VALUE ENGINEERING CONSTRUCTABILITY STUDY
OF THE

SR 92/FAIRBURN ROAD INTERCHANGE WITH I-20

PROJECT NUMBER: IM-NH-20-1(73)

August 14-15, 2006

VII. DEVELOPMENT SECTION
I. STAGE CONSTRUCTION
A. TEMPORARY DETOUR
1. "AS PROPOSED"

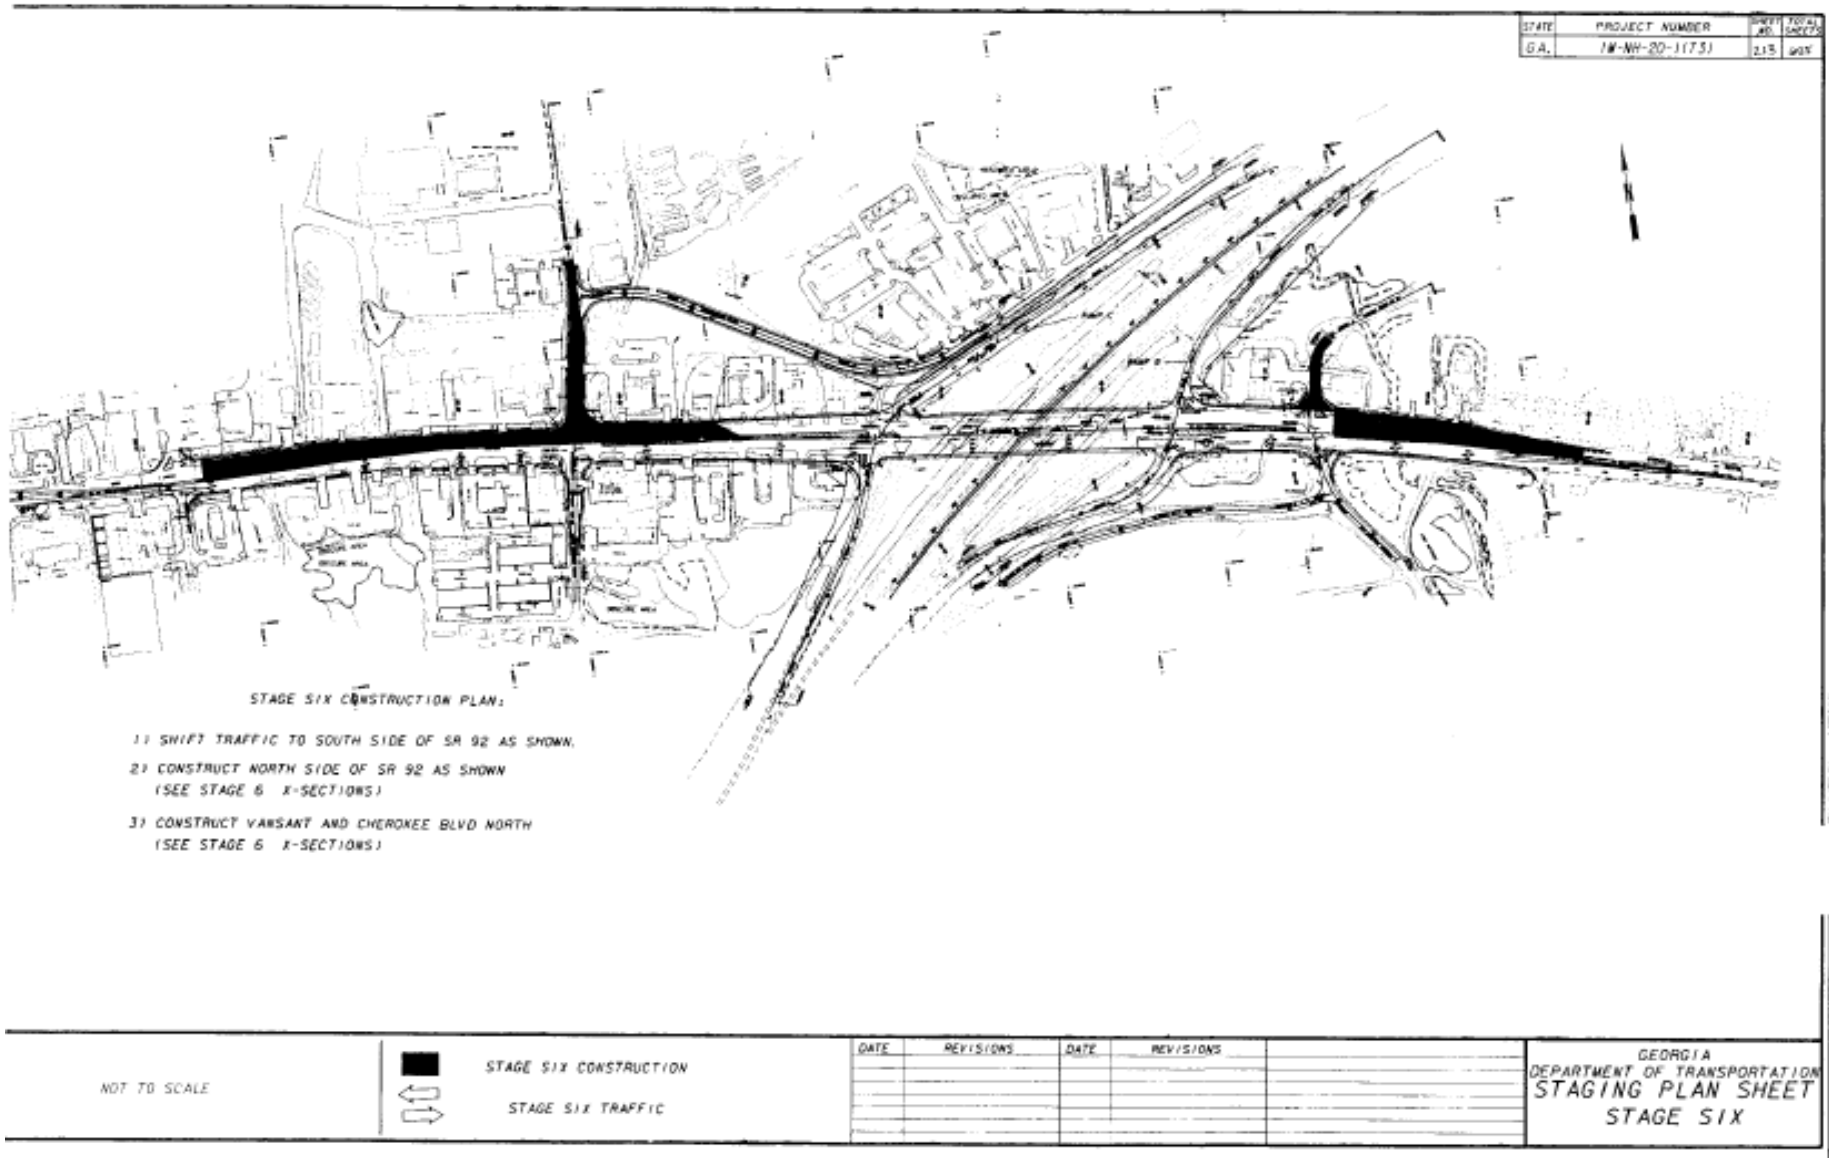
I. Stage Construction/Constructability: Six Stages with Temporary Detour Bridge.

The profile grade along SR 92 will be raised approximately 8 ft. at each end of the proposed new bridge. This difference in elevation is the major reason for the proposed construction plans containing six individual steps in the construction staging sequence. The staging requires the construction of a temporary detour bridge along the right side of the existing SR 92 Bridge over I-20. The proposed temporary bridge is estimated to cost between $700,000 and $900,000 to install and remove as part of the staging plan. The temporary bridge will shift the traffic farther to the right along existing SR 92 and will reduce the profile grade of the detour only slightly less than 1 ft. compared to the as-planned final elevation of the permanent SR 92 Bridge. The only flexibility that is gained is from the temporary bridge being moved farther away from the existing bridge for side slope and lateral clearance, total demolition of the existing bridge and the ability to break the roadway into smaller segments.

The new bridge is 439 ft. long and 140 ft. wide, and the grade is raised approximately 8 ft. The span lengths are 2 end spans at 49 ft. and a 2 span continuous plate girder at 170 ft. each. The end bents are pile supported while the 3 interior bents are on deep spread footings. The end abutments are of the spill through type with 2 to 1 end slopes. The detour bridge is shown as a 63 ft. wide, 4 span 346 ft. long structure. The Contractor will design, construct and remove the detour bridge.

The Value Engineering Alternative will construct the project in two stages. This will require shifting the centerline to the right so the left side of the proposed bridge and the left side of existing bridge match. The change will also eliminate the need for the detour bridge.

VALUE ENGINEERING ALTERNATIVE ALIGNMENT

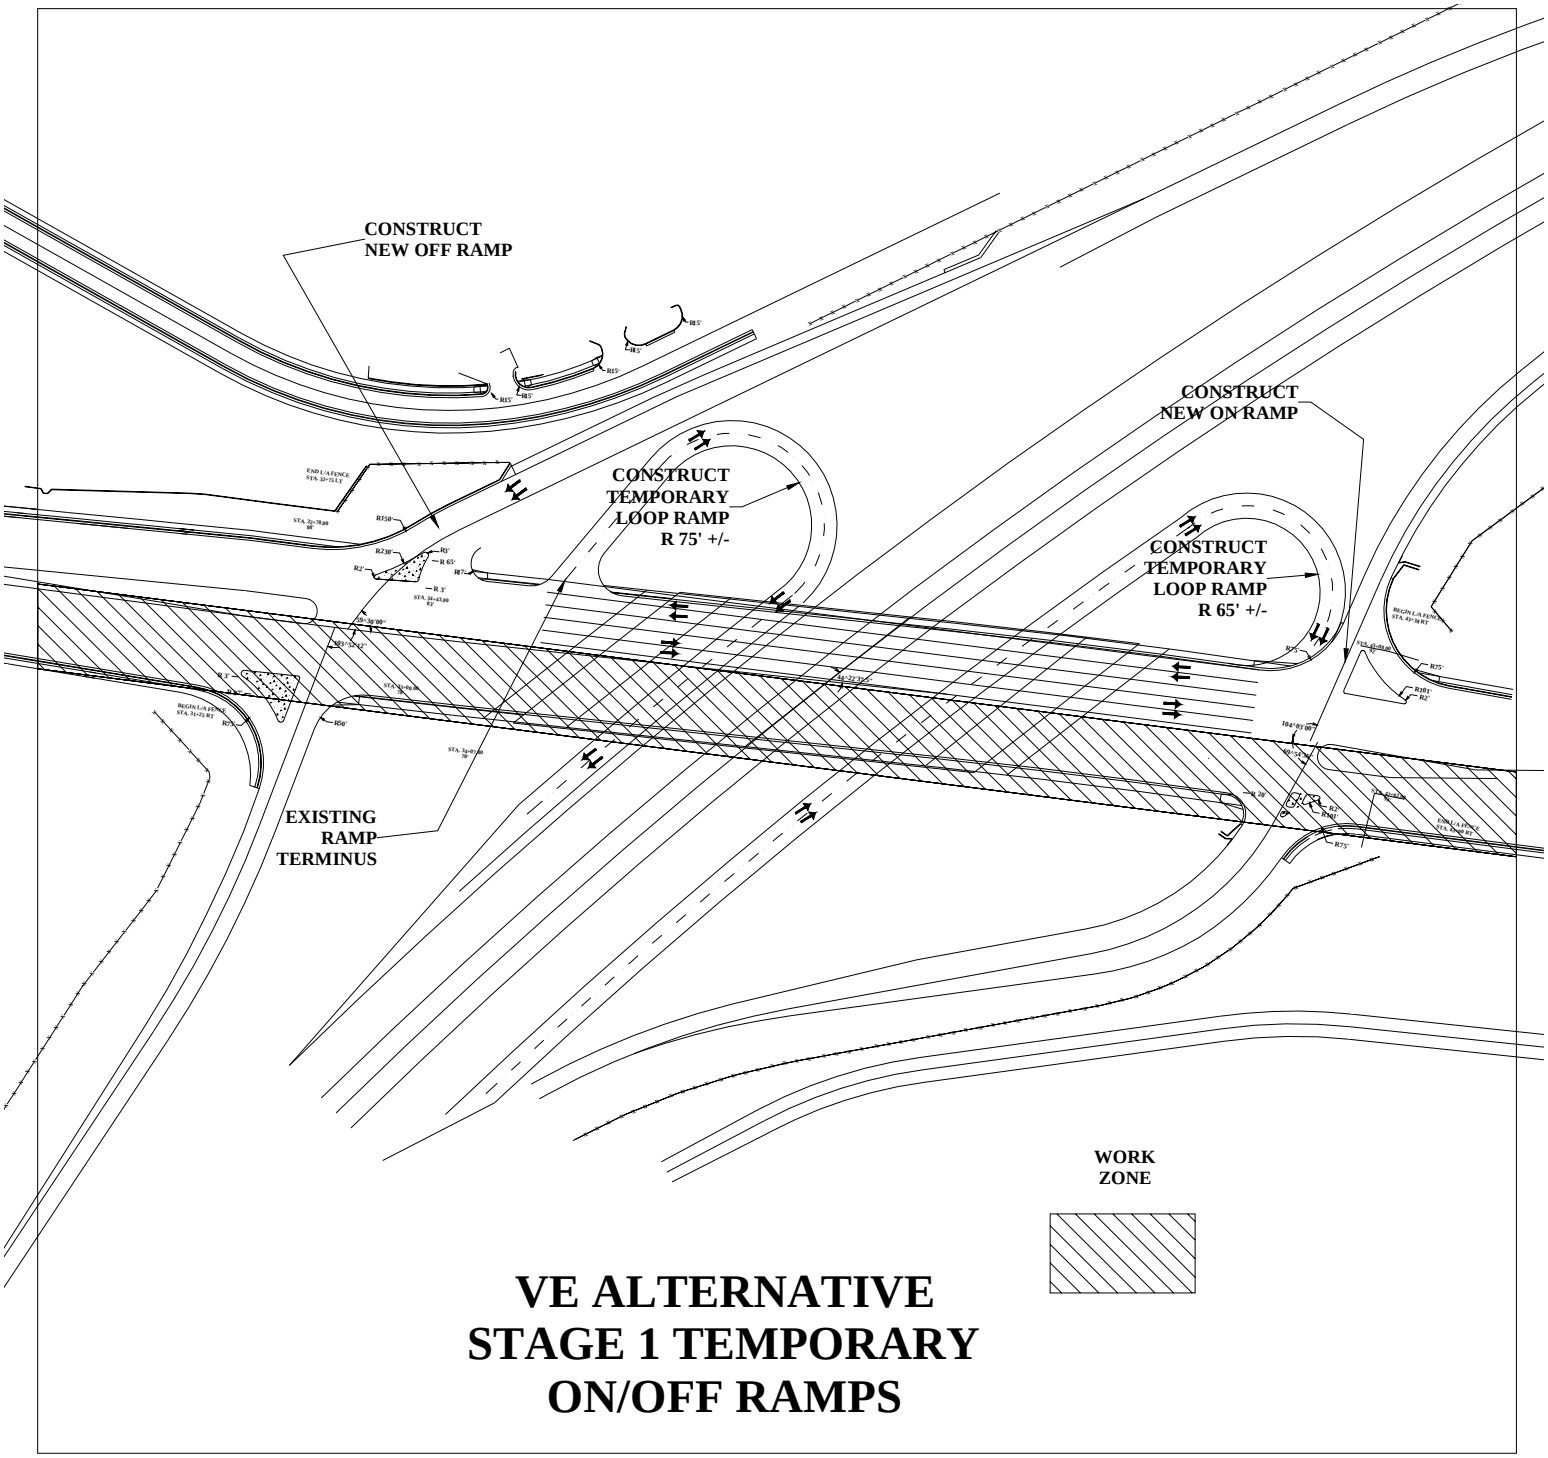
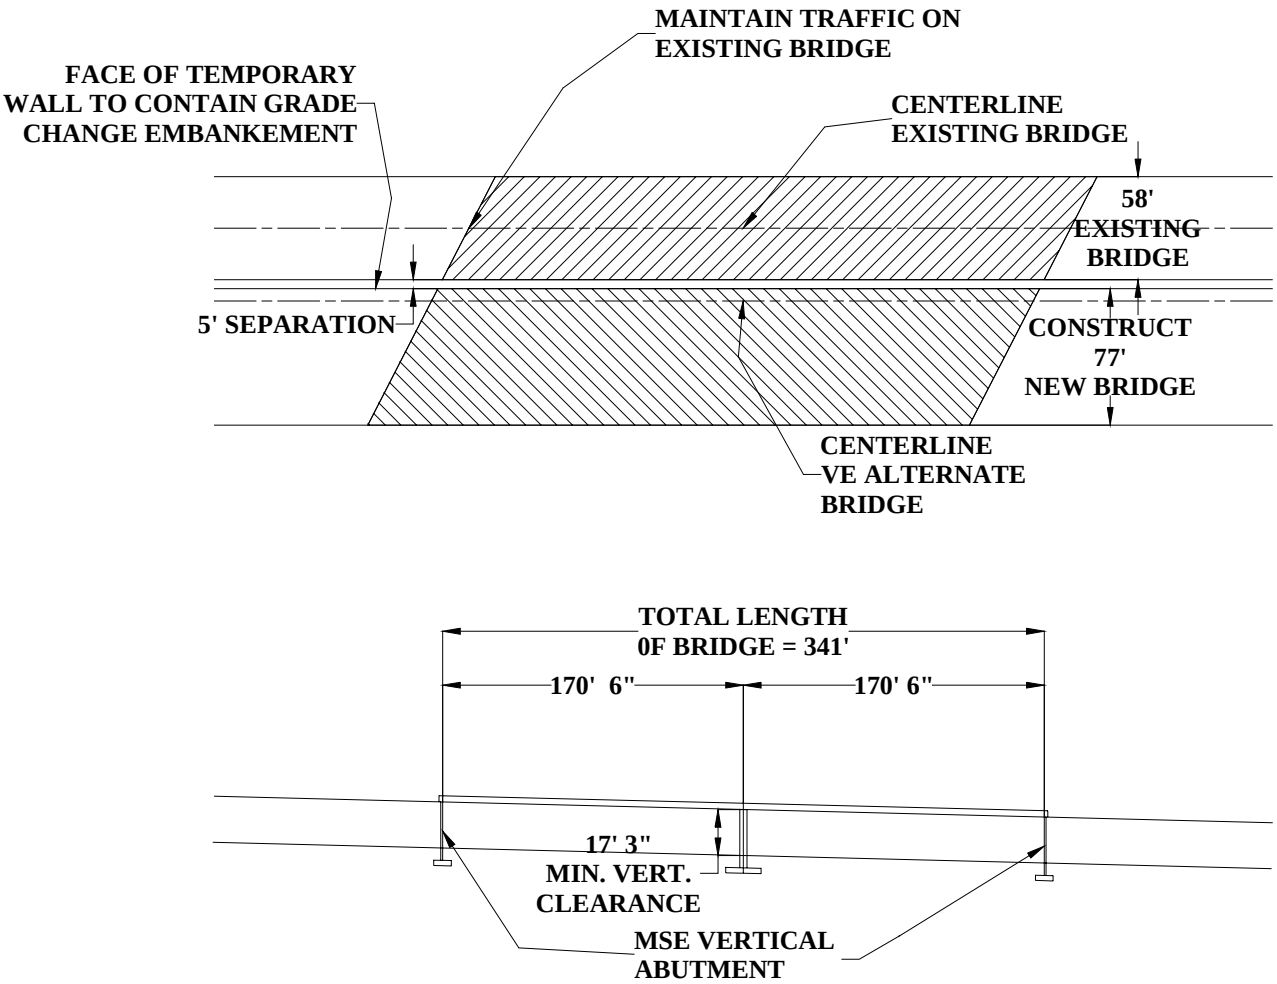
- The traffic will be maintained on the existing roadway.
- Construct westbound off ramp.
- Construct eastbound on ramp.
- Construct temporary loop ramps for the westbound on ramp and the eastbound off ramp.
- Construct 77 ft. +/- of the right side of the new SR 92 Bridge.
- Construct the right side of the project.

- Shift traffic to newly constructed SR 92 roadway and bridge.
- Demolition existing bridge.
- Construct remaining bridge.
- Construct left side of project.

There are no existing sidewalks on the old bridge or any sidewalks along either side of the existing SR 92 roadway. The Value Engineering Stage I constructed portion of the new bridge will be able to carry five lanes at 11 ft. in width along with the appropriate positive barrier protection to separate the raised portion of the right side roadway from the existing travel lanes. This configuration matches the basic lane layout on the existing bridge.

The Value Engineering Alternative will construct the end abutments using MSE vertical abutments to eliminate the short end spans and will also incorporate 6 ft. diameter drilled shafts to replace the spread footings.

VE ALTERNATIVE
STAGE 1 CONSTRUCTION

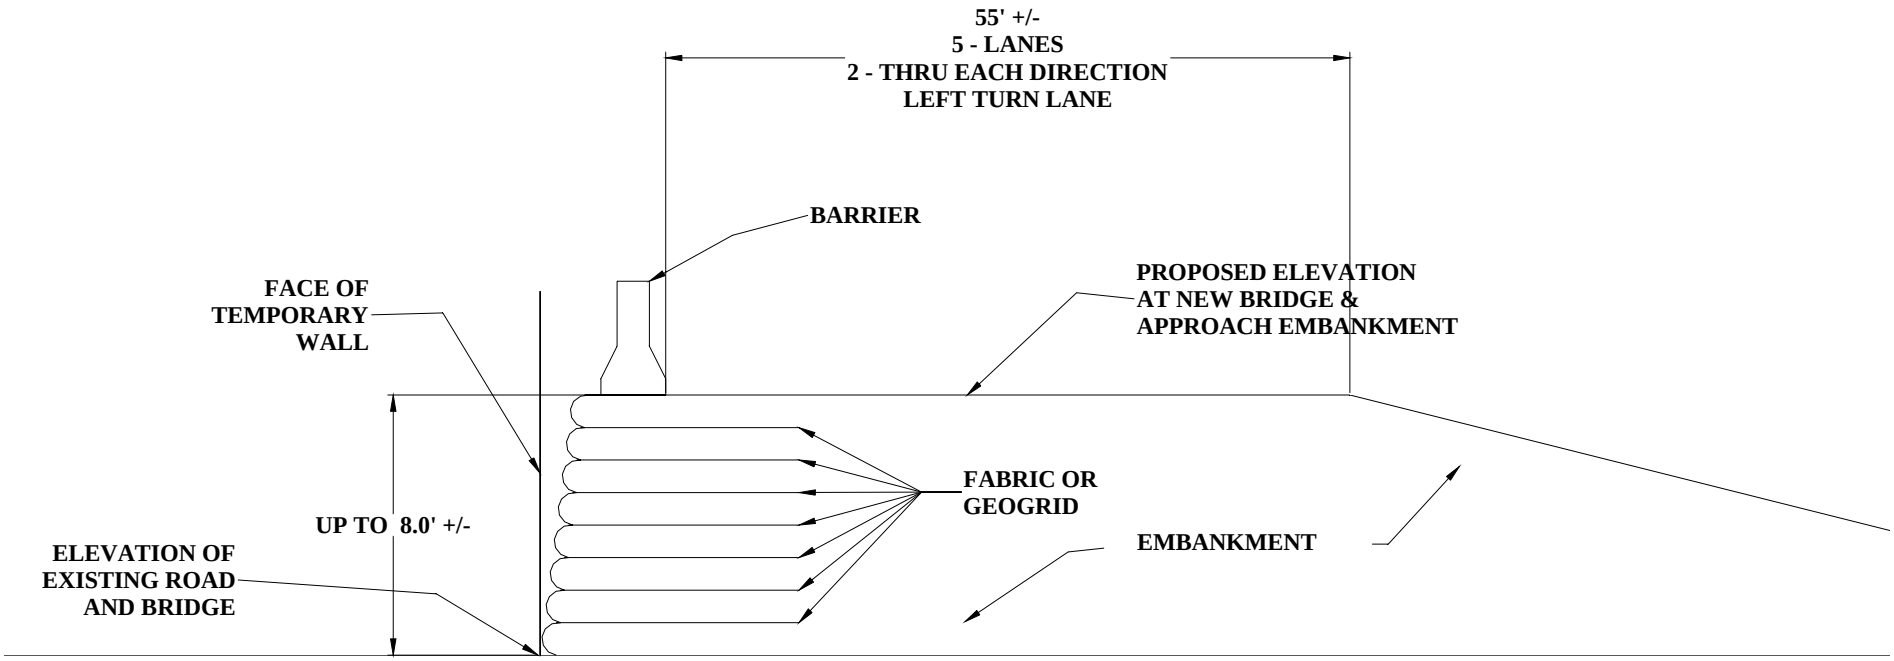
The Value Engineering Alternative proposes the use of reinforced earth walls to contain the vertical 8 ft. difference in elevation. These walls will be left in place as the traffic is shifted to the right side of the roadway and the left side of the roadway is raised to the final profile grade with fill material. It is believed that a fabric or geo-grid temporary wall will provide the most economical retaining wall and the shortest construction time.

VE Stage 1
Right Side Notch for
Shawnee Trail/Vansant Road

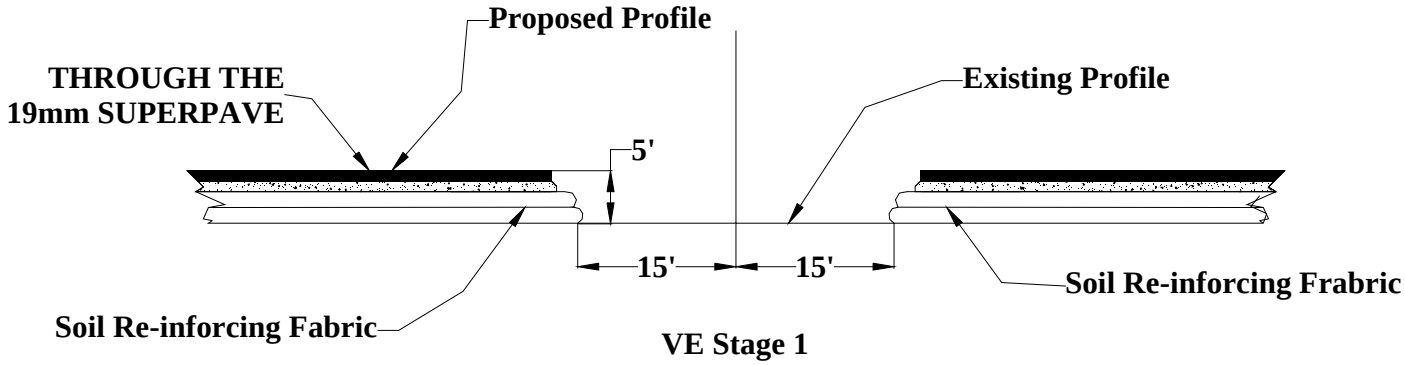
This Value Engineering Alternative proposes to construct the permanent pavement through the 19 mm Superpave along with the curb and gutter from Cherokee Blvd. to the existing Ramp "D". The existing Ramp "D" will be held at its current location and elevation. The new right side lanes through the 19 mm Superpave, along with the curb and gutter, will be constructed from existing Ramp "D" to the approach slab of the new bridge. Perform the same operation on the new right side lanes from the approach slab to the existing Ramp "A". The existing Ramp "A" will be held at its current location and elevation. Construct the right side of SR 92 from existing Ramp "A" to Shawnee Trail Road through the 19mm Superpave along with the curb and gutter. Leave Shawnee Trail Road open to traffic on the existing pavement. Construct the right side of SR 92 from Shawnee Trail Road to Pine Drive through the 19 mm Superpave along with the curb and gutter.

FILLING THE NOTCH

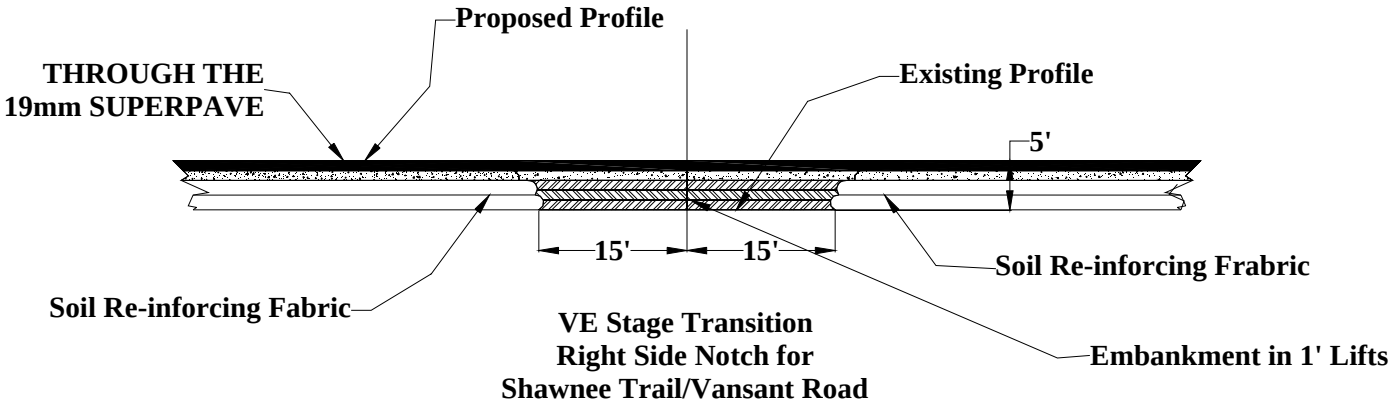
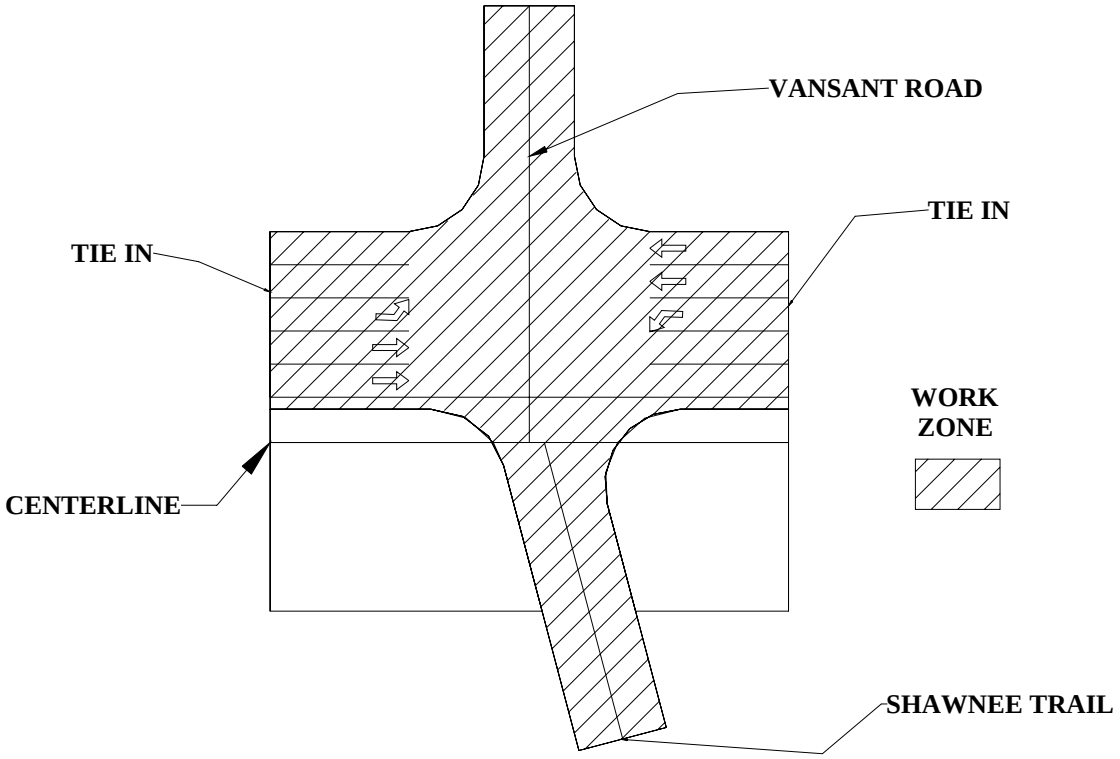
Over a weekend, raise the grade of the left side, of Vansant Road and Shawnee Trail to the proposed grades. This is accomplished by removing the existing asphalt and placing embankment in 1 ft. lifts until the appropriate grade is reached to place base and asphalt. Flagmen and lane closures would be required in order to place fill and pavement

FEATHERING CONNECTIONS TO SHAWNEE TRAIL AND VANSANT ROAD

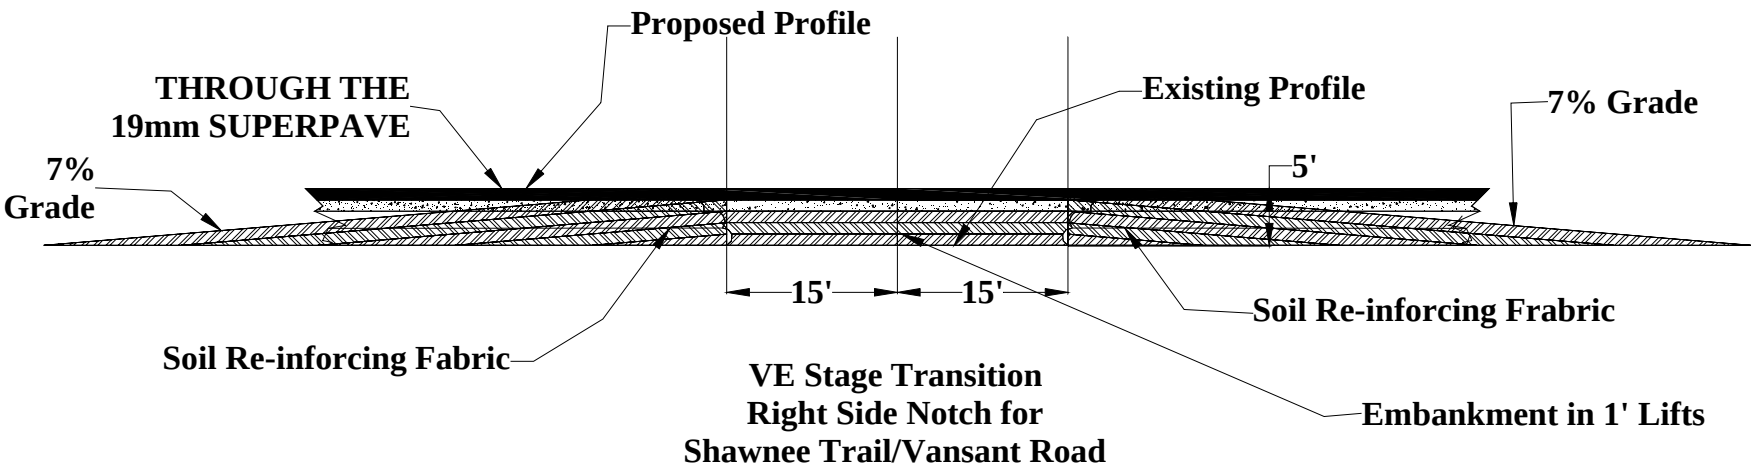
Shawnee Trail Road will require another detour as part of this staging. The work on raising the intersection of Shawnee Trail Road 5 ft. to tie-in with the new profile grade of SR 92 can be done in advance of the weekend work at the ramps. Pope Road (CR 93) or Prestley Mill Road (CR 142) can be signed as appropriate for a detour that could allow this work to be done several weeks in advance of the traffic shift. A special condition should be included in Section 150 to limit the amount of time that the detour could remain in place. Section 108 should be included to apply liquidated damages to minimize the possibility of exceeding the time allowed for completing the work. It appears that this detour could function for several weeks with minimal disruption.

Vansant Road intersection with SR 92 will require the elevation to be raised 5 ft. when traffic is shifted to the new right side lanes. Due to the presence of the Texaco Station at this intersection, the disruption to traffic ingress and egress from SR 92 will need to be held to a minimum. It appears that a night time detour would work on the weekend of the traffic shift on SR 92 or ingress and egress could be maintained on existing SR 92 while traffic on Vansant Road is detoured to CR 91 and back to SR 92 while the elevation of Vansant Road is raised prior to the shifting of traffic on SR 92. If traffic is detoured onto CR 91 the amount of time should not exceed approximately two weeks. A special condition should be included in Section 150 along with Section 108 to cover liquidated damages for exceeding the amount of time allowed.
